Submission on Halswell Rugby League Football Club application

Proposed new lease and pavilion rebuild, and sports field lighting upgrade.

Tony Nikkel
23 Hyde Place,
Halswell
24/04/2020

Figure 4 – Showing the estimated perspective viewpoints of Images 2 and 3. (Viewpoints have been overlaid)

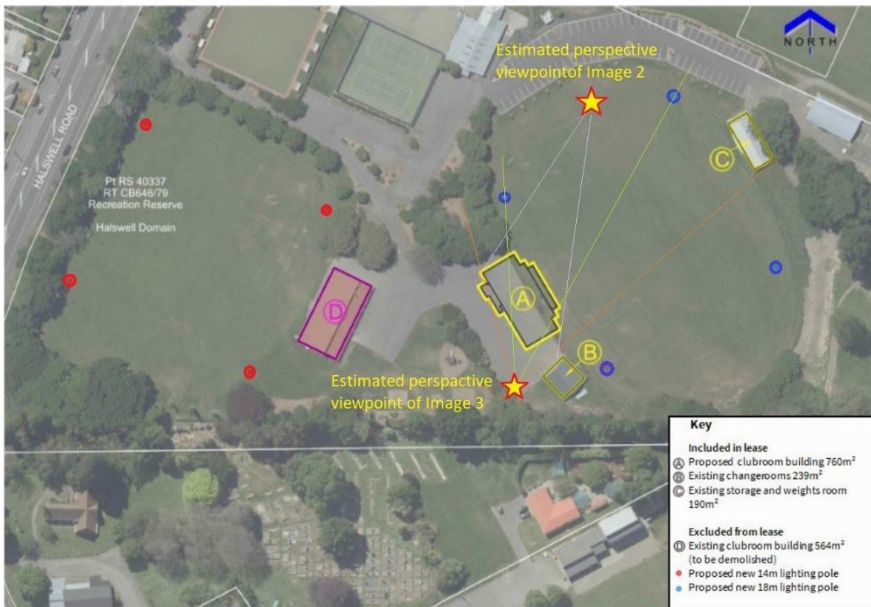
The 3D visualisations shown in the consultation documents have not accurately represented the height of the proposed new light pole structures. The new light poles are depicted at less than half the proposed 18 meters height applied for. While this is not a deliberate action, it is an oversight in the preparation and presentation of the public consultation documents.

Figures 2 and 3 illustrate the significant scale error in the depiction of the light pole structures in the 3D visualisations. They are depicted at 6 metres and 8 meters in height instead of the proposed 18 meters. Figure 4 shows the estimated perspective viewpoints of the presented images to assist with interpretation of the overlaid information.

Figure 2 – Consultation 3D visualisation which inaccurately depicts two of the proposed new poles from this perspective at 6 metres and 8 meters in height instead of 18 meters. *(Estimated heights have been overlaid)*

Figure 3 – Consultation 3D visualisation which does not show one of the new 18-meter-high poles that would be visible from this perspective. *(Estimated heights have been overlaid)*

Figure 5 – Appendix 6.11.13 clause 3

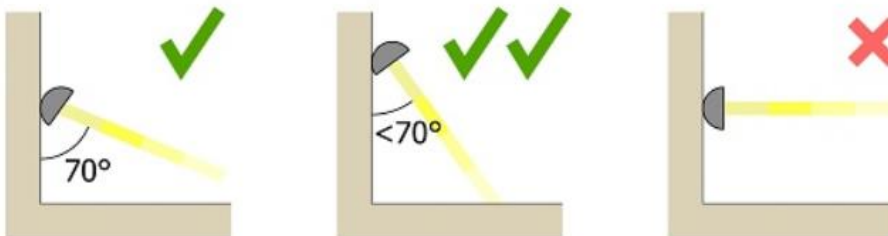
I am aware that there are a small number of properties in Hyde Street that back on to the North boundary of Halswell Domain that could experience some visible glare from the proposed new lighting on sports field number one. (No.15 to No.21 of Hyde Place would be the most affected by any potential glare.)

While it is unrealistic to expect that there will be no glare from the proposed new lights, it is submitted that the amount of glare from the new lights can be minimised if the height of the lights above the ground is kept to a minimum.

Figure 7 – Looking across the field in a SE direction – Proposed 18m poles highlighted.

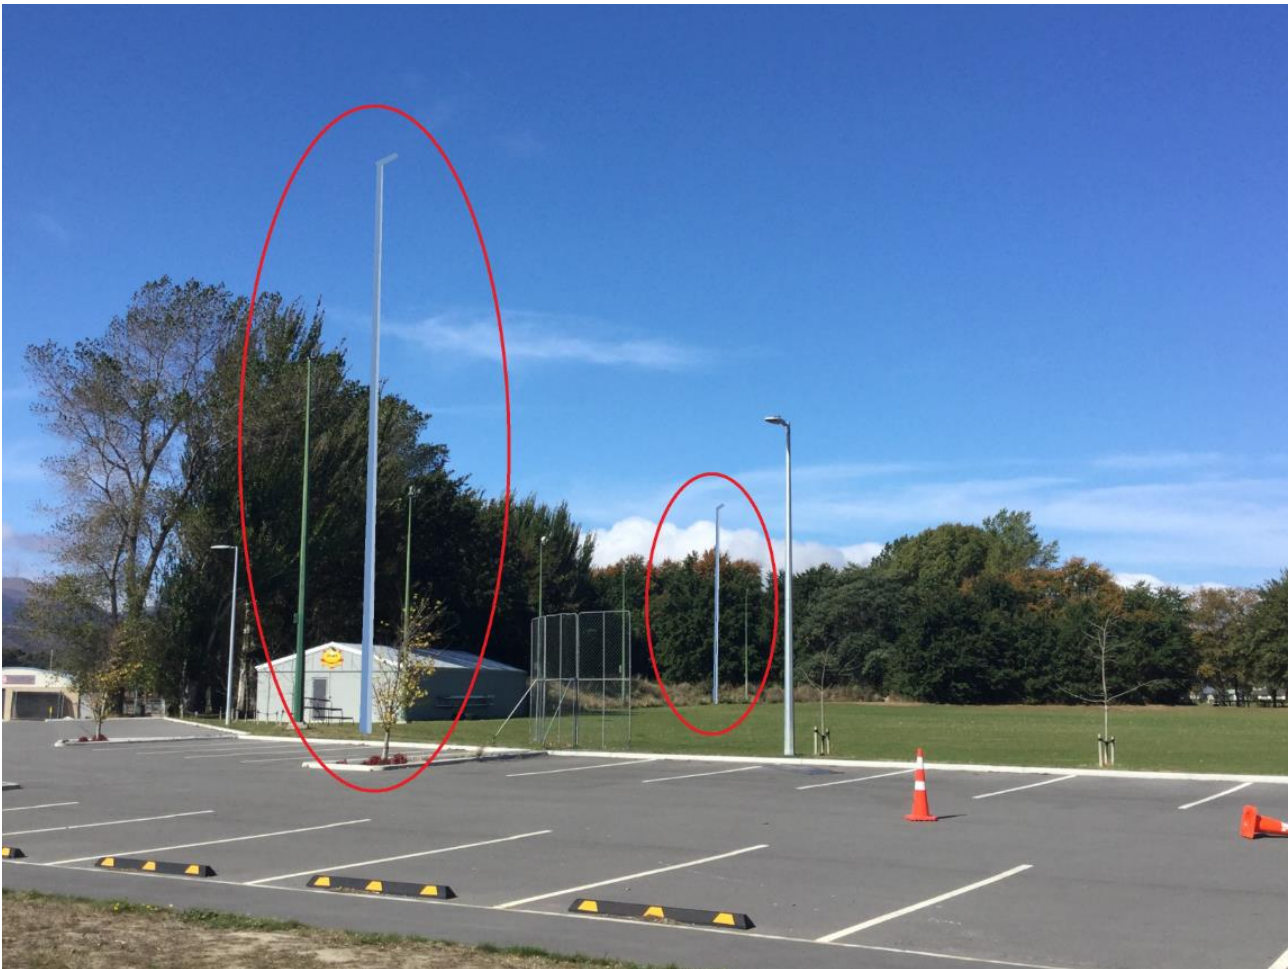
To illustrate some of the negative visual adverse effects this submission addresses I have marked up the following 3D visualisations. They are shown as Figures 6 to 9.

The visualisations are approximate, but have been prepared to the best of my ability with the tools I have at hand. The scale of the proposed 18m poles is based on a multiplier of 1.5 times the height of the existing 12-meter-high poles.

In summary I oppose the proposal for 18-meter-high light poles around the ‘number one’ playing field for the reasons expressed above.
